NOTICE OF MEETING

The City of Lake Elmo
Planning Commission will conduct a meeting on
Monday September 9, 2019
at 7:00 p.m.

TO: Planning Commission
FROM: Ben Prchal, City Planner
AGENDA ITEM: Variance Requests for 8126 Hill Trl. N
REVIEWED BY: Ken Roberts, Planning Director

TO: Planning Commission
FROM: Ken Roberts, Planning Director
AGENDA ITEM: **Planned Unit Development Concept Plan Review for Applewood Senior Housing – Eagle Pointe Business Park**
REVIEWED BY: Ben Prchal, City Planner

APPLEWOOD POINTE OF LAKE ELMO Site Survey Analysis

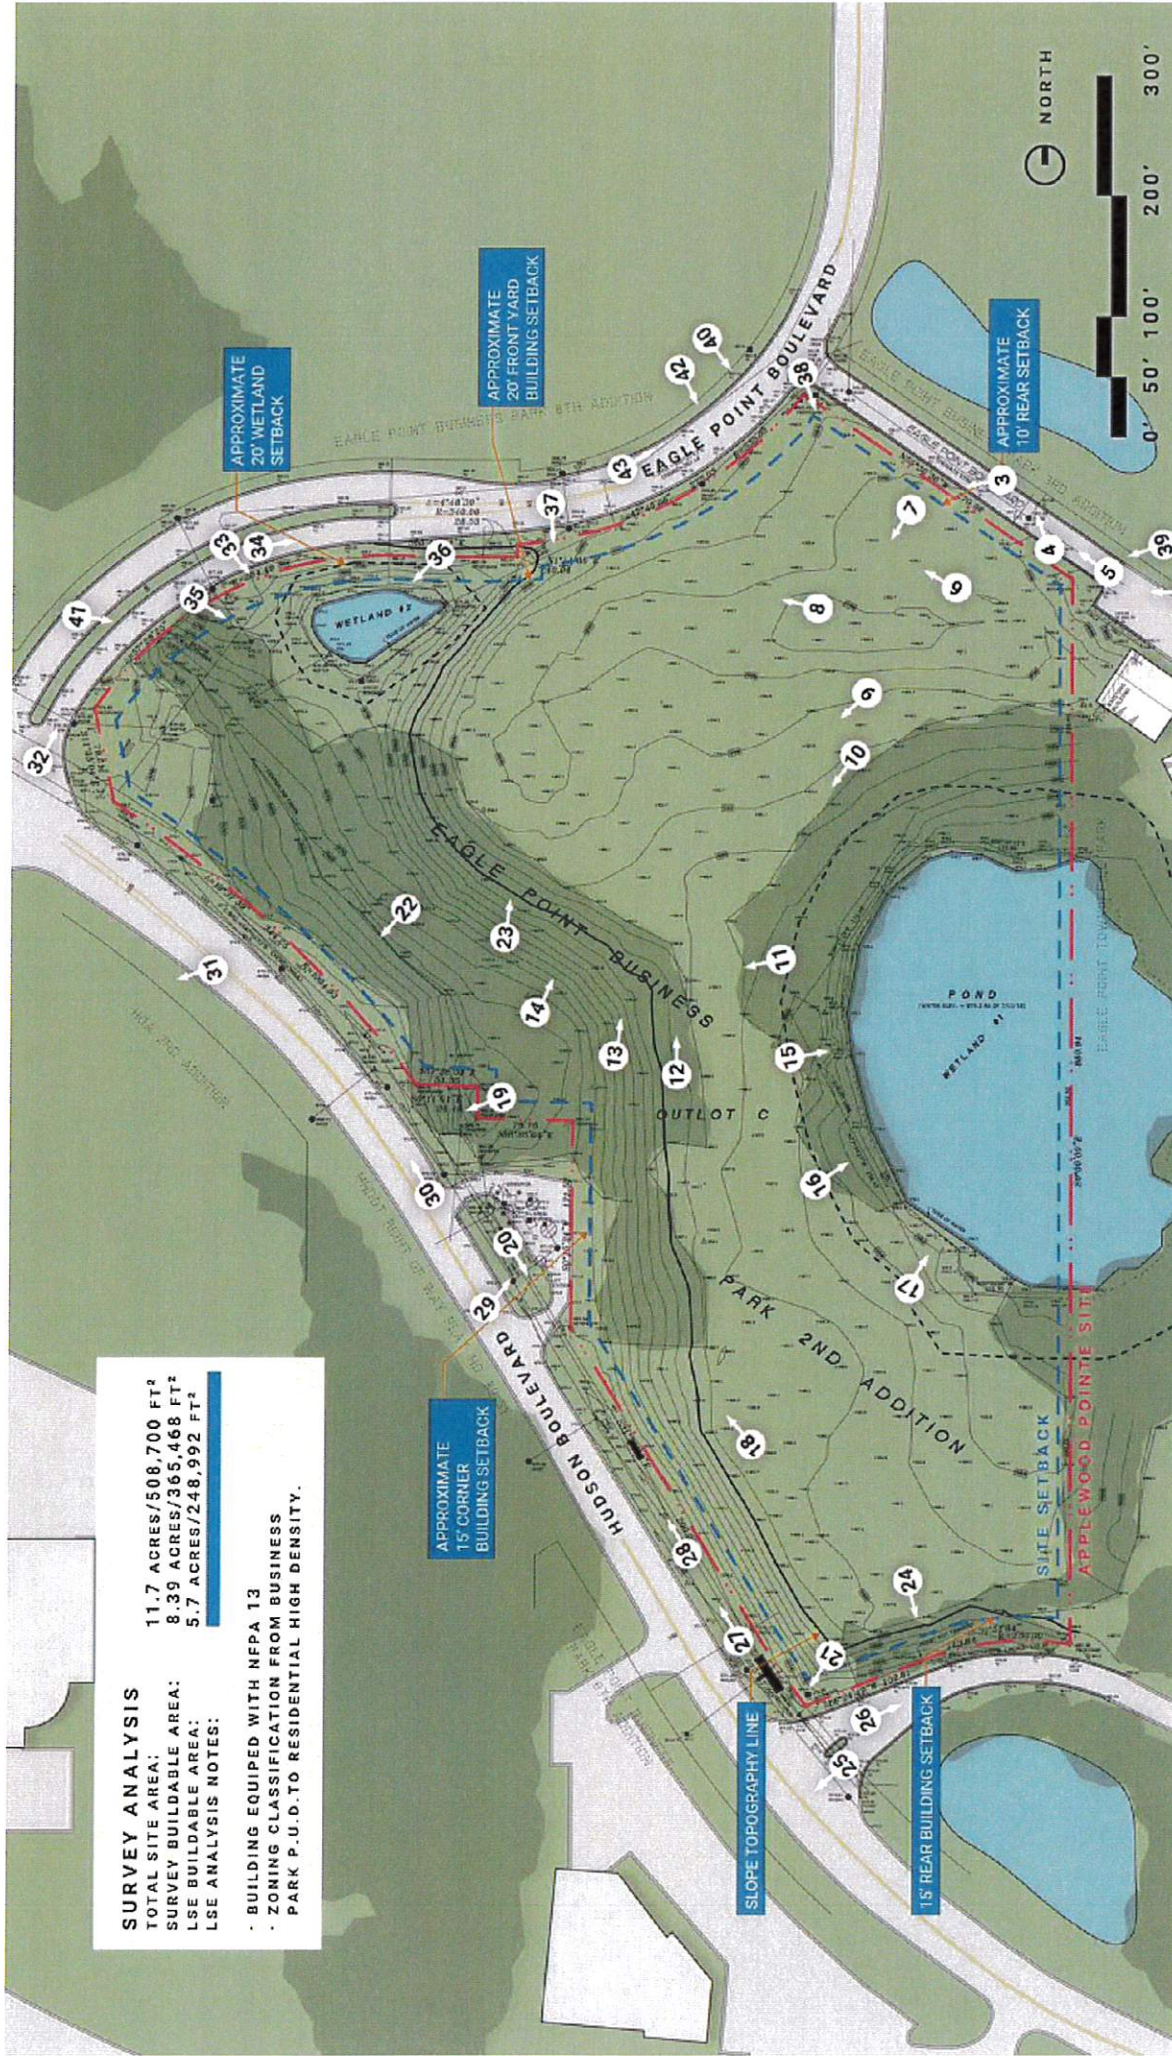
Site Plan. The concept site plan includes one 4-story building with 100 residential units, 100 below grade parking spaces and 72 on-grade (surface) parking spaces. This plan also shows areas for community gardens, bocce ball, a deck over-looking the wetland and a gazebo for the residents of the building.

Vehicular Access. The proposed concept plan shows two access driveways into the site from Eagle Pointe Boulevard. The spacing of the proposed driveways in relation to the existing driveway to the north of site do not meet City standards. The City Engineer's review memo (attached) provides more details about streets, driveways and access for this site.

Setbacks. The concept site plan shows a site setback line around the perimeter of the property. The proposed location of the building should meet or exceed all City-required setbacks from the street rights-of-ways and the wetlands. The City will need to verify that the proposed parking spaces near Eagle Pointe Boulevard will meet the required setback of 10 feet from the street right-of-way.

Parking. The City's Zoning Code requires one parking space per studio and 1 bedroom unit, two parking spaces per 2 and 3 bedroom unit and at least one visitor space per four units. With the proposed mix of 100 units, the City Zoning Code requires the developer to provide at least 225 parking spaces on site (2 per unit (200 total) and 25 visitor parking spaces). In this case, the developer is proposing a total of 172 parking spaces – including 100 parking spaces in the proposed building and 72 surface parking spaces spread throughout the site.

- *Stormwater Management*
 - The concept plan does not address storm water management. The proposed development is subject the construction of a storm water management plan and system that meets State, South Washington Watershed District (SWWD) and City rules. All stormwater facilities need to be designed and installed in accordance with City and South Washington Watershed District (VBWD) requirements.
